CITY OF FORT COLLINS
BID # 5731
CITY PARK POOL RENOVATION
ADDENDUM NO. 1

SPECIFICATIONS AND CONTRACT DOCUMENTS

OPENING DATE: 3:00 P.M. (our clock) September 24, 2002

NEW DRAIN BASIN AND PIPE

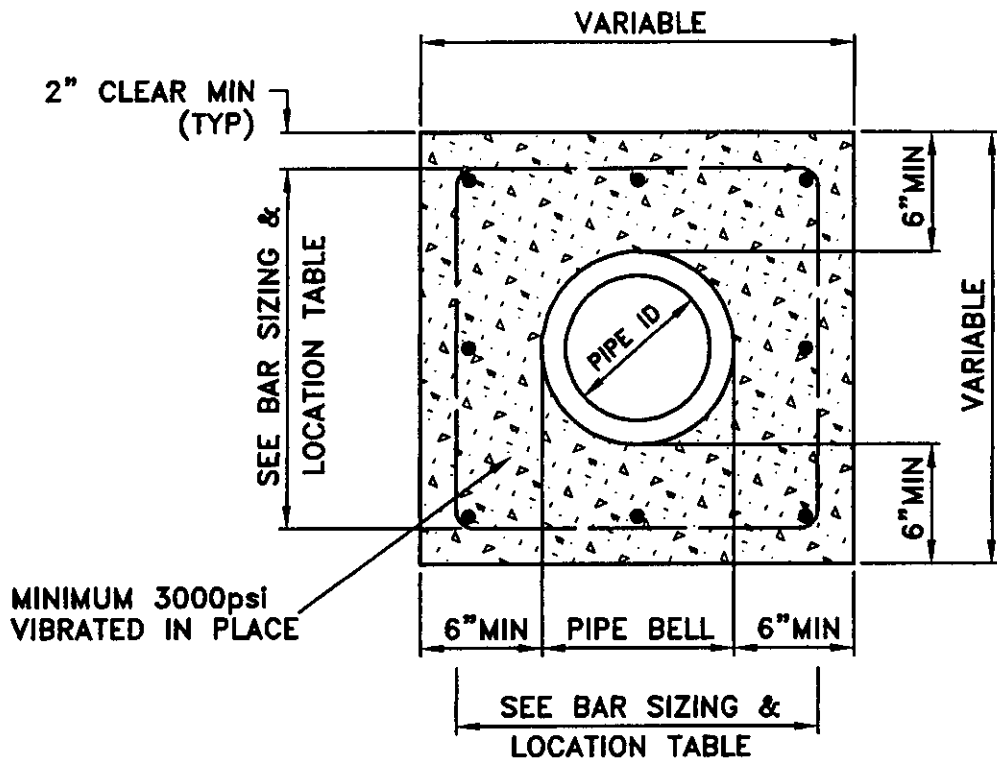
A new 12" drain basin and pipe, east of the proposed mechanical building, to be installed per attached drawing: NEW DRAIN BASIN AND PIPE.

REINFORCED CONCRETE ENCASEMENT

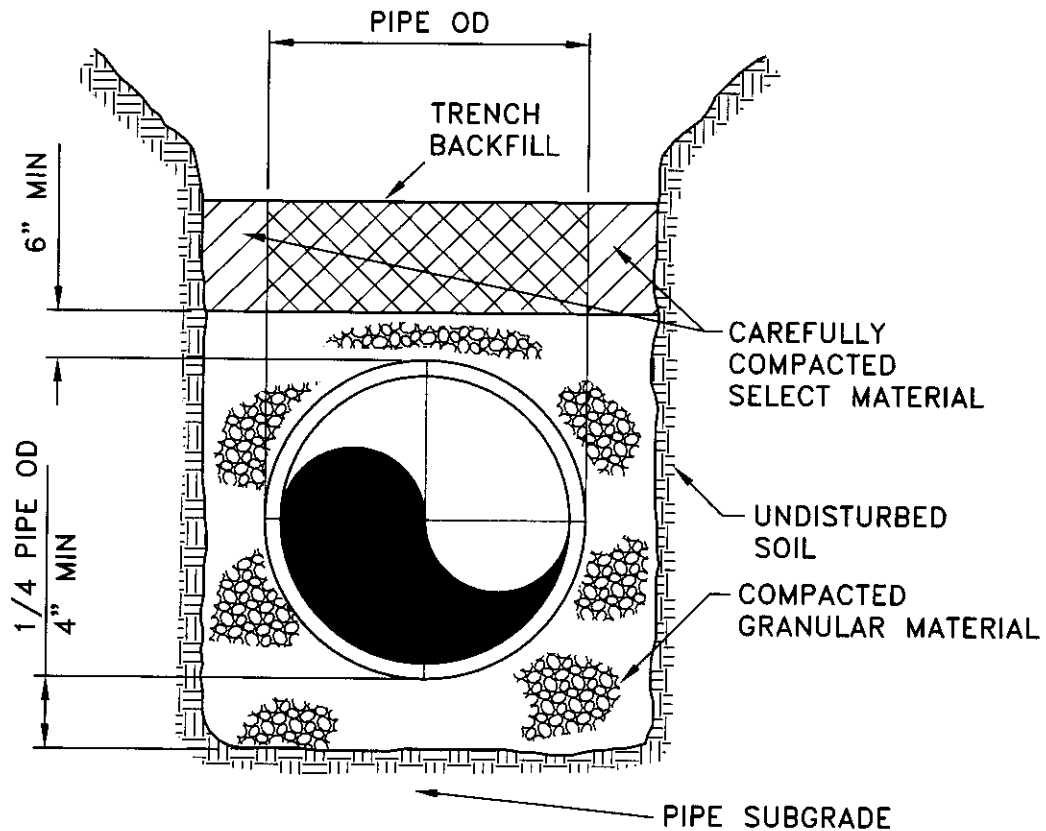
Concrete encasement in storm line 1 to be per attached detail: REINFORCED CONCRETE ENCASEMENT – F28.

Bedding of all storm sewer and force main pipe to be modified class B per attached detail: MODIFIED CLASS B BEDDING DETAIL.

Revise storm line chart. New storm line chart included with pipe bedding detail above.

ADD2

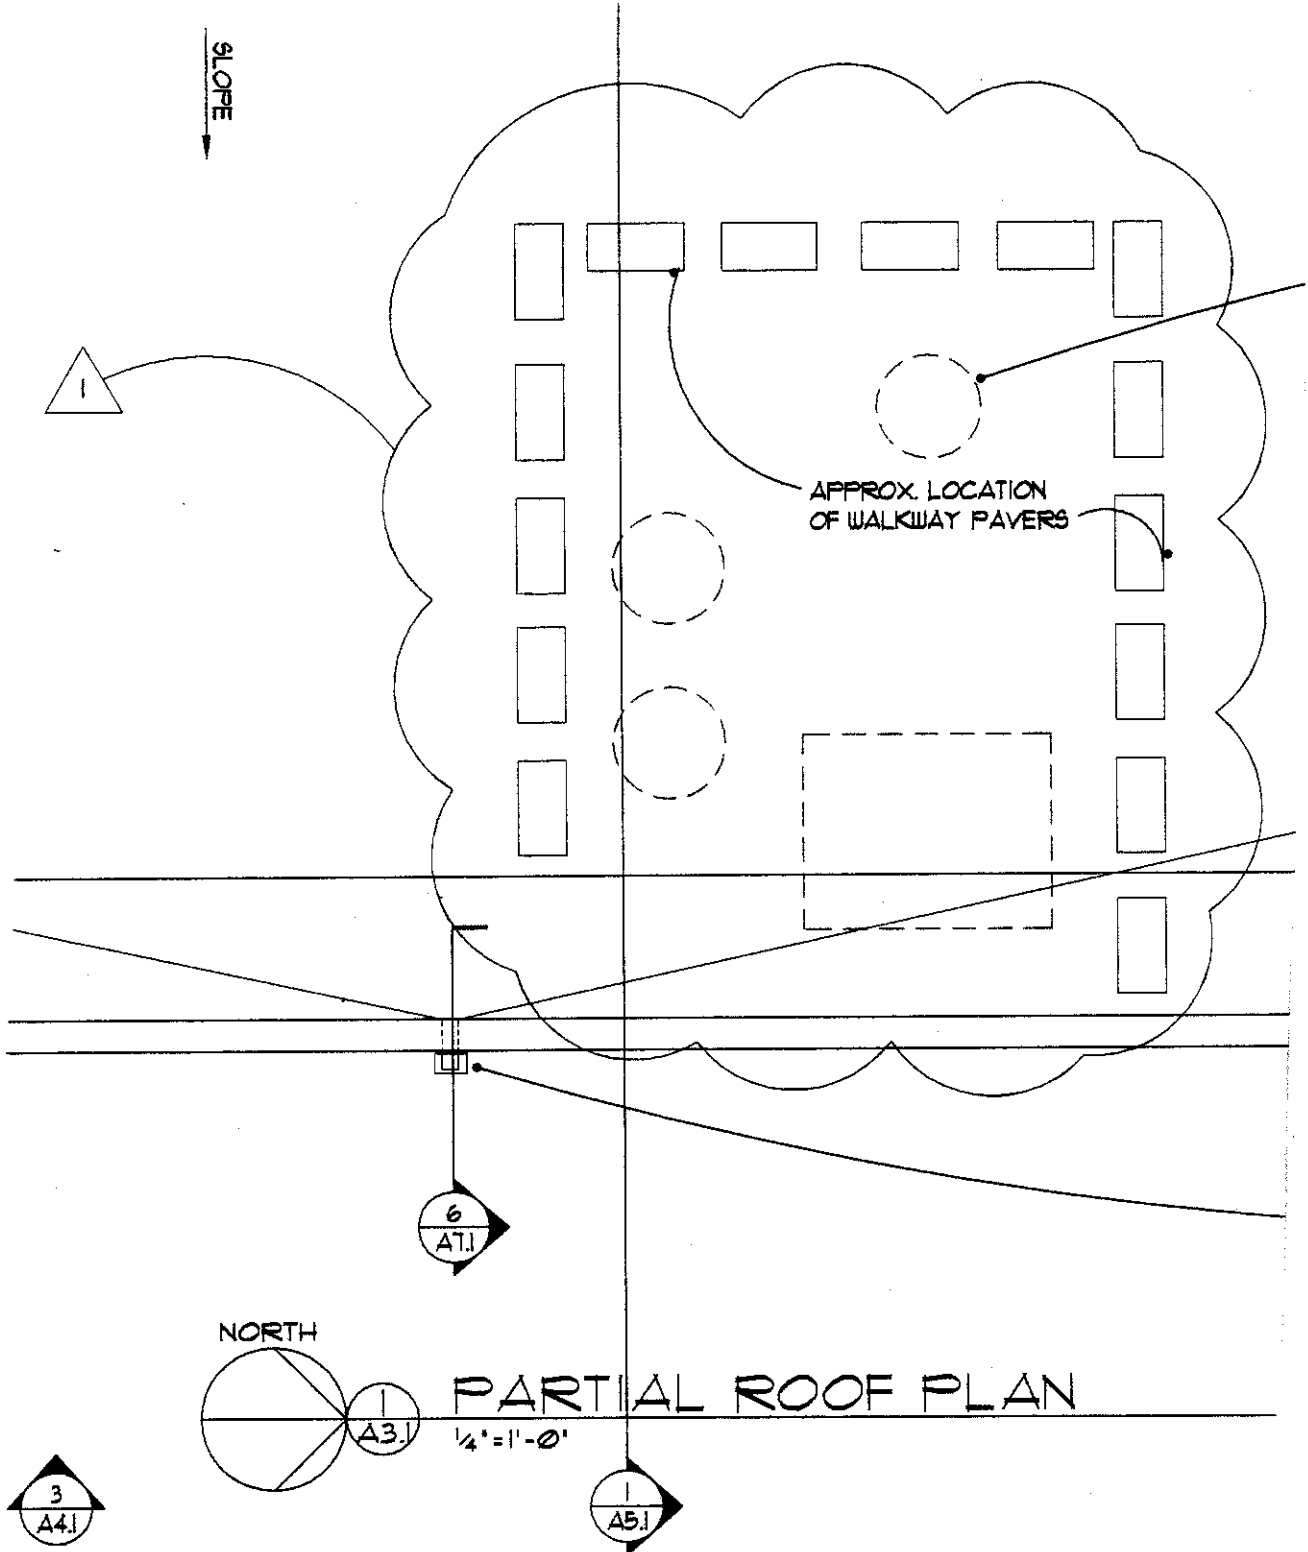
See attached PARTIAL ROOF PLAN (ADD2) for layout of pavers or walkway pads.

8 INTERIOR ELEVATION

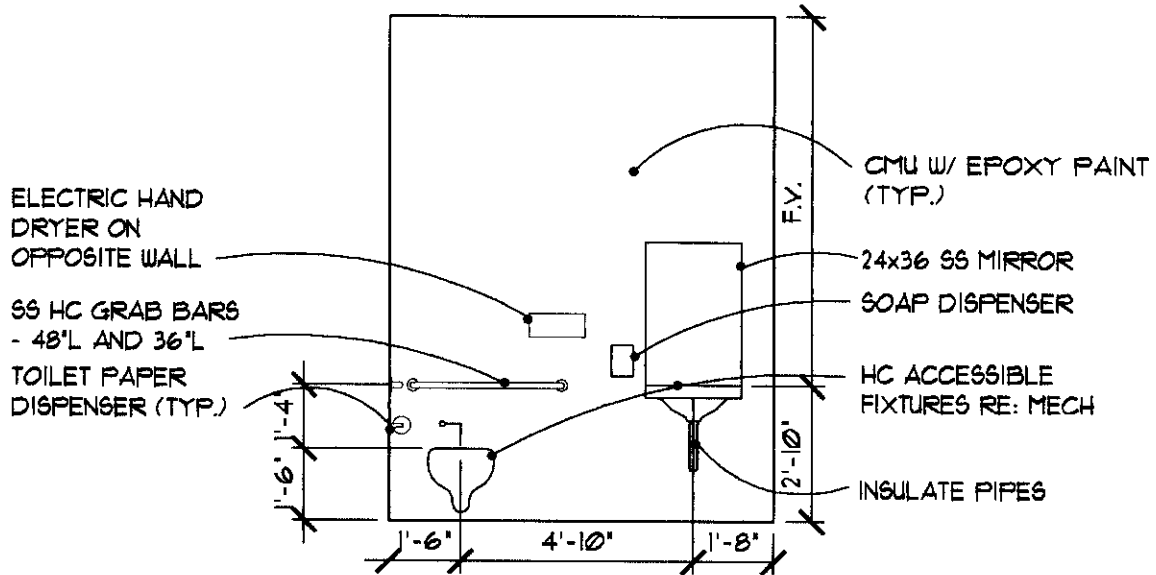
Add one electric hand dryer to each toilet room, as shown on interior elevation 8/A7.1.

Add the attached toilet room interior elevation 8/A7.1 (ADD1).

GUTTER DROPOUT

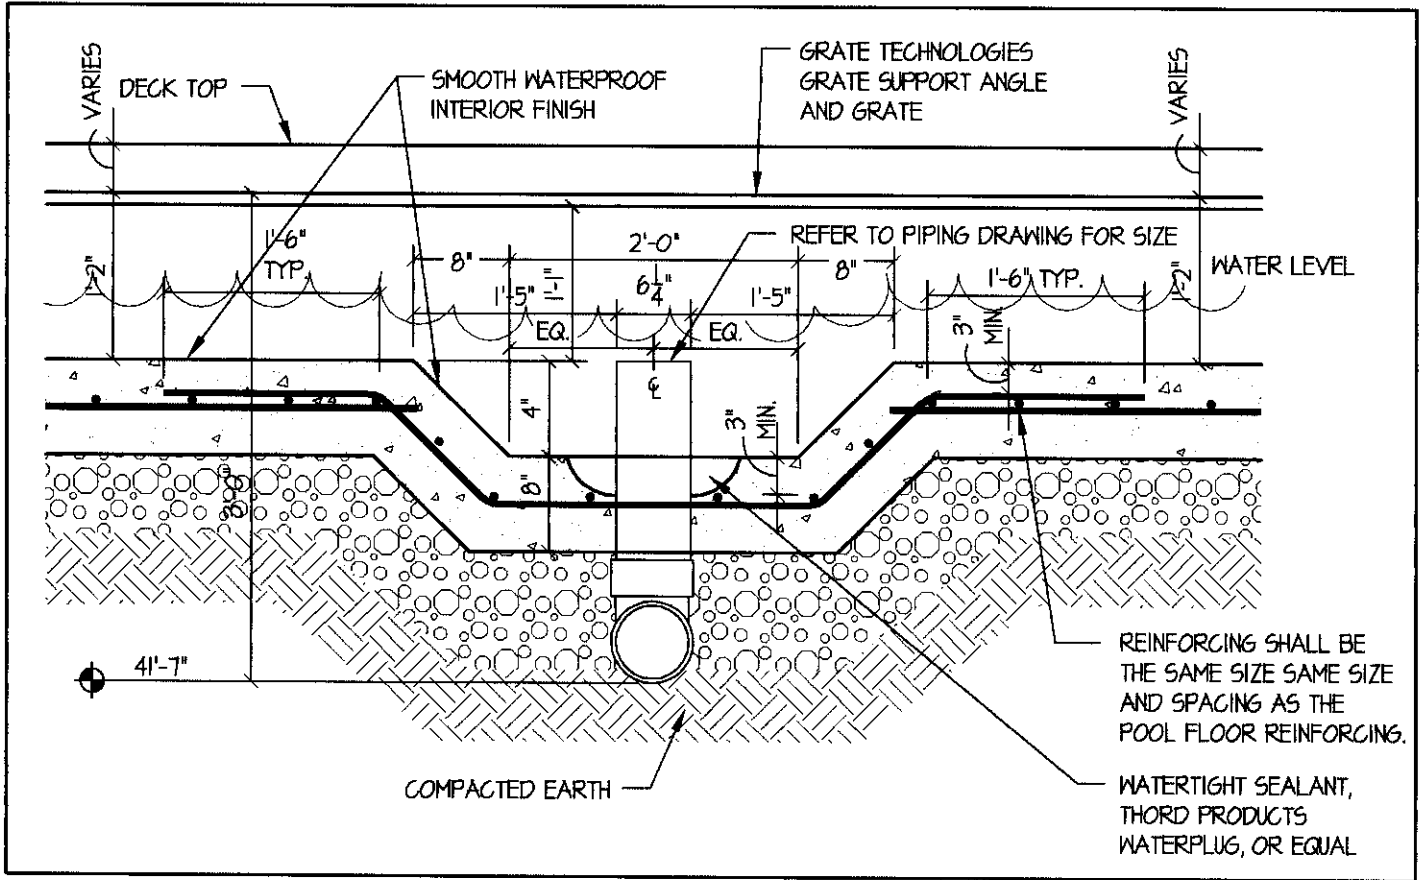
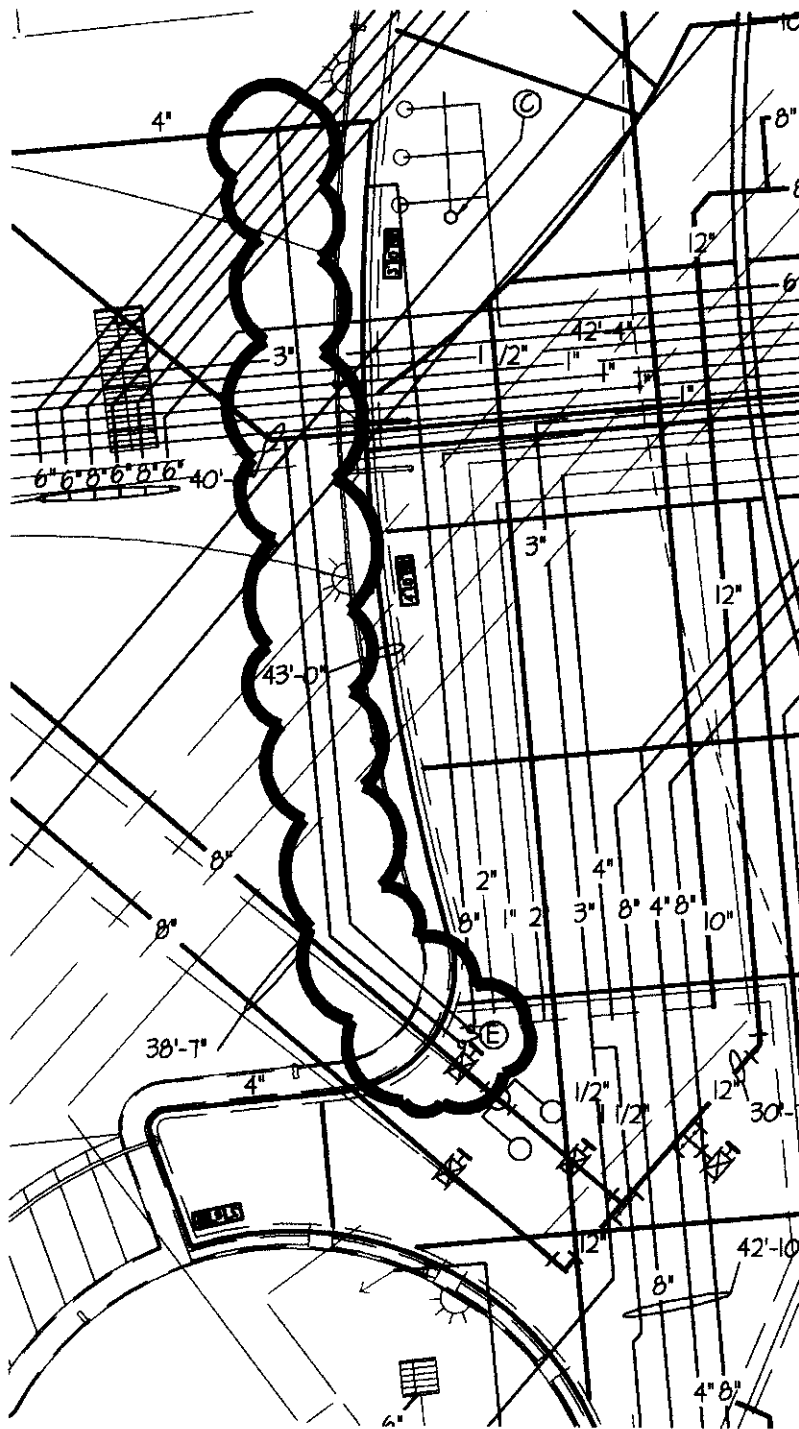
Refer to the attached detail 613x1 for alteration to GUTTER DROPOUT detail.

PIPING LAYOUT CORRECTIONS

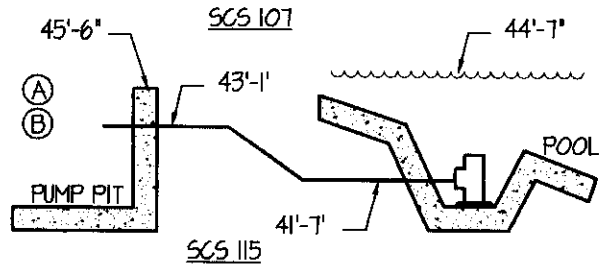
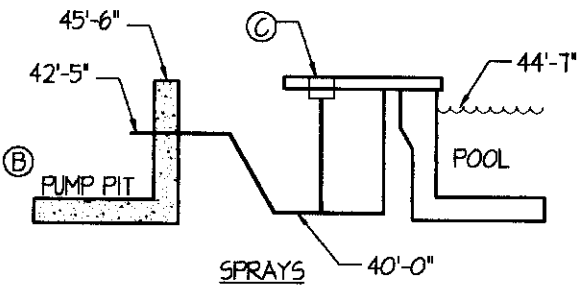
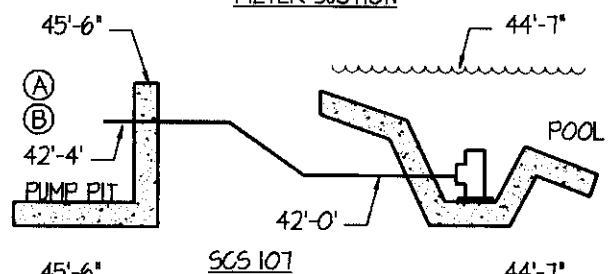
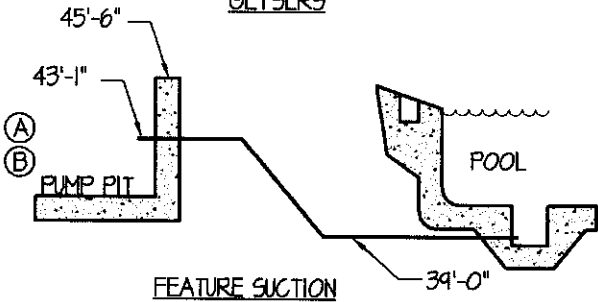
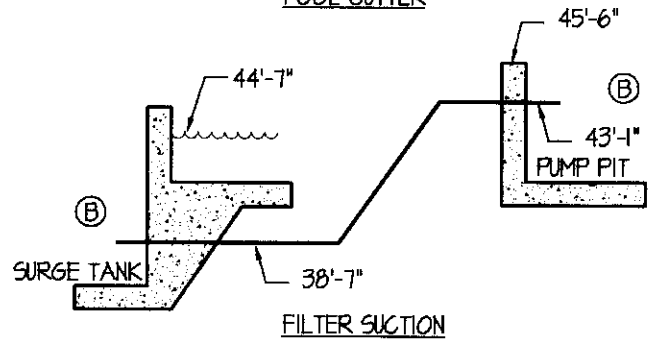
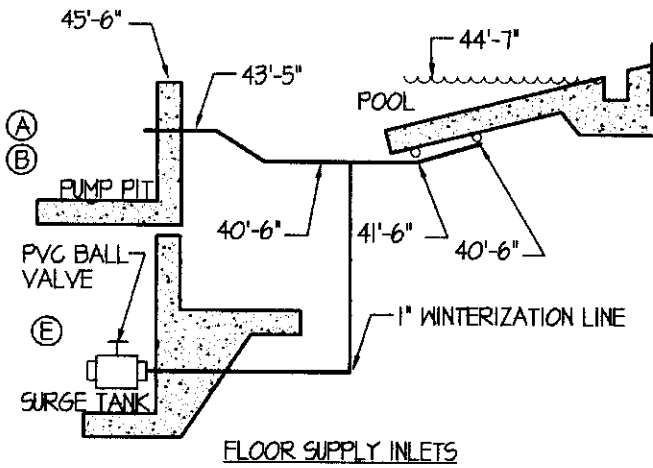
Refer to attached details 71x1, 75x1, 76x1 for pipe winterization additions/clarifications.
